SM No. CSP9392000031

9
Grade, Drain, Bridge, and Paving necessary to reconstruct SR 611 at US 90, known as State Project No. SP-9392-00(003) / 100710301, in the County of Jackson, State of Mississippi.
Project Completion: April 15, 2013

PROJECT: SP-9392-00(003) / 100710301 – Jackson County

FIGURE 1 - REFERENCE DIVISION 100 - PAGE 101-1

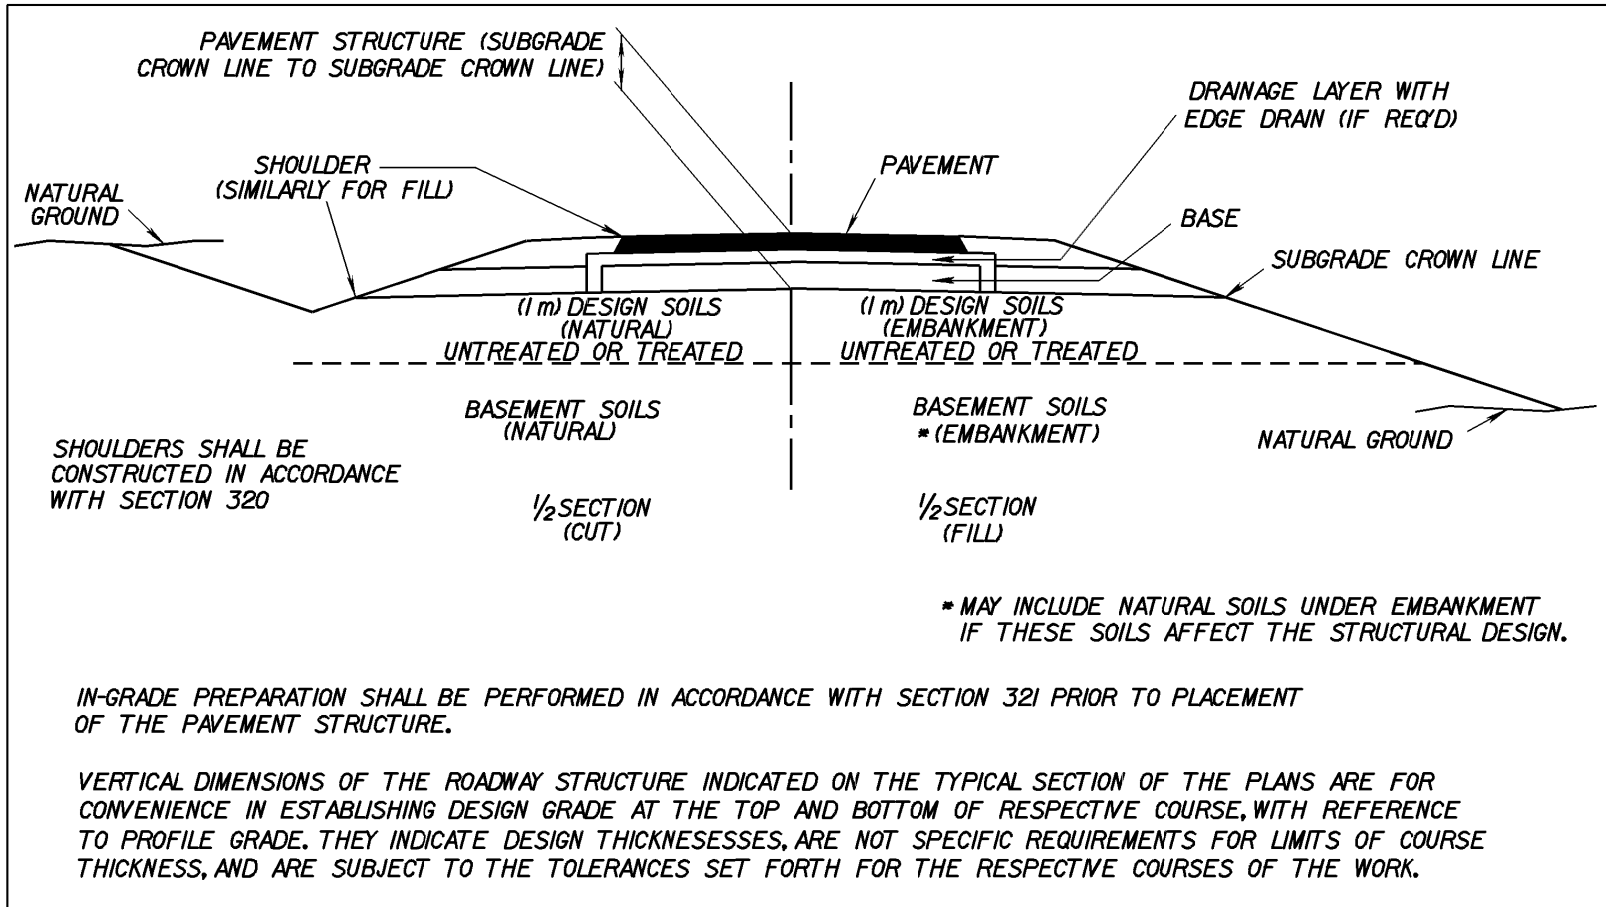
Delete Figure 1 at the end of Section 101 on page 101-13, and substitute the following:

VERTICAL DIMENSIONS OF THE ROADWAY STRUCTURE INDICATED ON THE TYPICAL SECTION OF THE PLANS ARE FOR CONVENIENCE IN ESTABLISHING DESIGN GRADE AT THE TOP AND BOTTOM OF RESPECTIVE COURSE, WITH REFERENCE TO PROFILE GRADE. THEY INDICATE DESIGN THICKNESSES, ARE NOT SPECIFIC REQUIREMENTS FOR LIMITS OF COURSE THICKNESS, AND ARE SUBJECT TO THE TOLERANCES SET FORTH FOR THE RESPECTIVE COURSES OF THE WORK.
